General Electric Company  
175 Capital Avenue, San Jose, CA 95128

MFN No. 038-92  
Docket No. STN 50-605  
EEN-9224

Subject: **GE Response to Agenda Items Discussed During the GE/NRC  
Reactor Systems Branch Meeting on November 20-21, 1991**

Enclosed are thirty-four (34) copies of the GE response to the subject discussion items, numbered 3,6,7 and 17.

Table 6.3-1

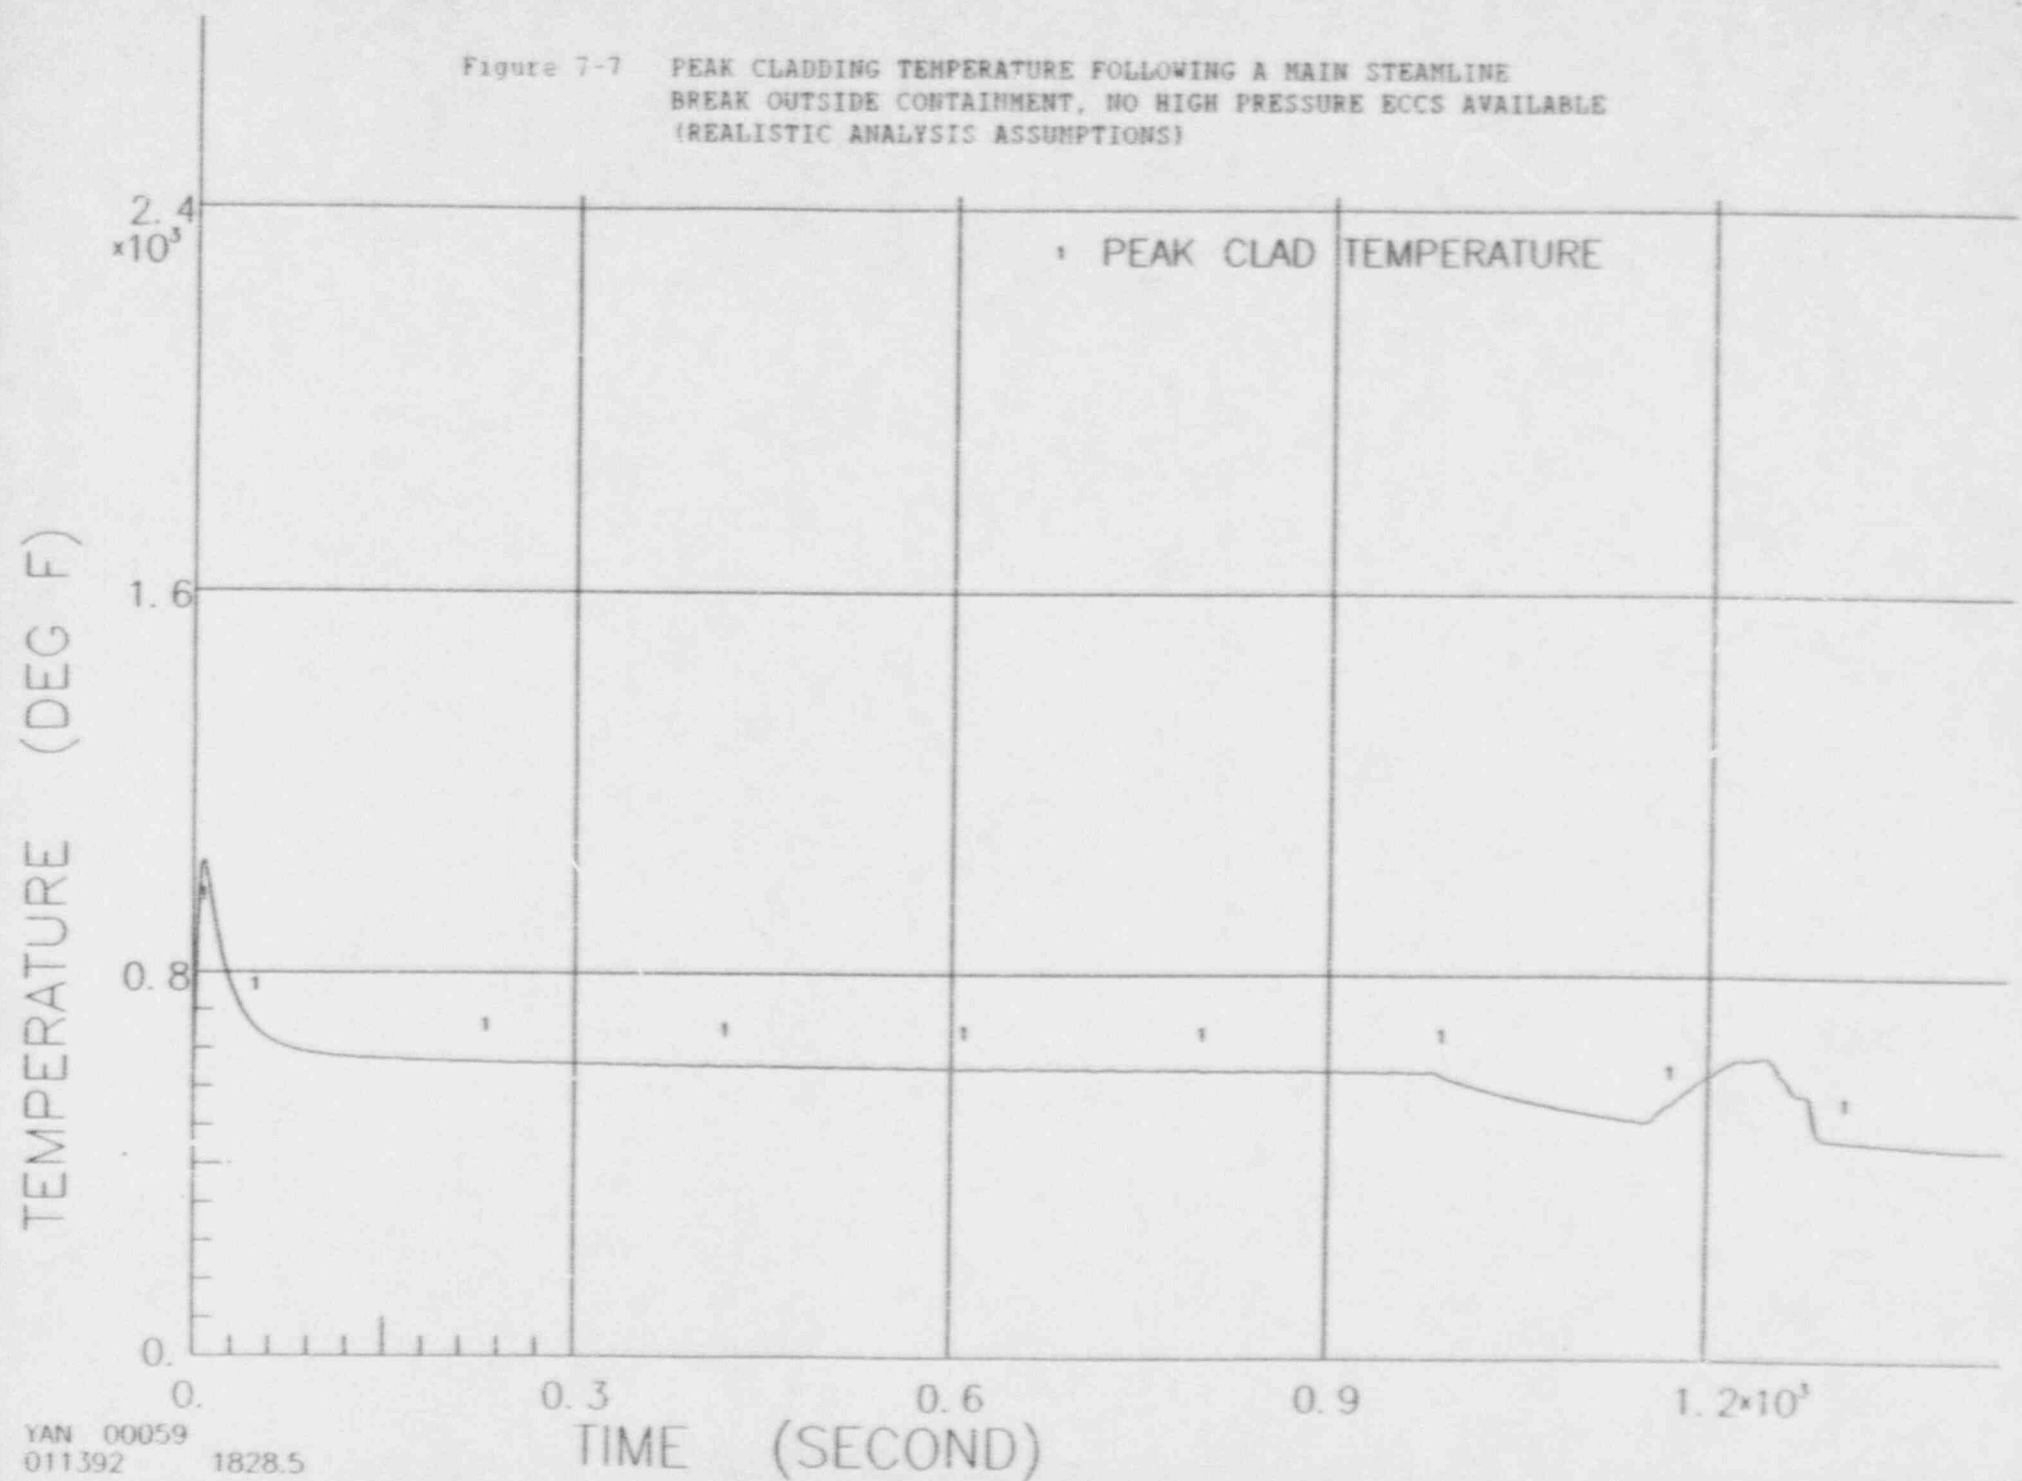
An 8 minute high drywell pressure bypass timer has been added to the ADS initiation logic to address TMI action item II.K.3.18. This timer will initiate on a Low Water Level 1 signal. When it times out, it bypasses the need for a high drywell signal to initiate the standard ADS initiation logic.

For all LOCAs inside the containment, a high drywell signal will be present and ADS will actuate 29 seconds after a Low Water Level 1 signal is reached. All LOCAs outside the containment become rapidly isolated and any one of the three high pressure ECCS can control the water level. The high drywell pressure bypass timer in the ADS initiation logic will only affect the LOCA response if all high pressure ECCS fail following a break outside the containment. For this case the ADS will automatically initiate within 50 seconds (8 minute timer plus 29 second standard ADS logic delay) following a Low Water Level 1 signal.

An analysis was performed to evaluate the adequacy of the 8 minute bypass timer. As discussed above this analysis involves multiple failures. Therefore it is part of the PRA success criteria realistic LOCA evaluation. The main difference between the input assumptions for this case and those in Section 6.3.3 of the SSAR is the use of a realistic decay heat curve (i.e. ANS 5.1). A complete circumferential break of the main steamline outside the containment (which is representative of those LOCA cases where no high drywell signal is present.) was evaluated. The key results from this analysis are given in Figures 7-1 through 7-7. The peak cladding temperature (PCT), refer to Figure 7-7, for this case is less than 1100°F which is well below the 2200 °F licensing limit. This PCT is due to the initial voiding in the core at the beginning of the event as in the case of the design basis evaluation. The heatup caused by the core uncover late in the event is negligible. These results confirm the acceptability of the 8 minute high drywell pressure bypass timer.
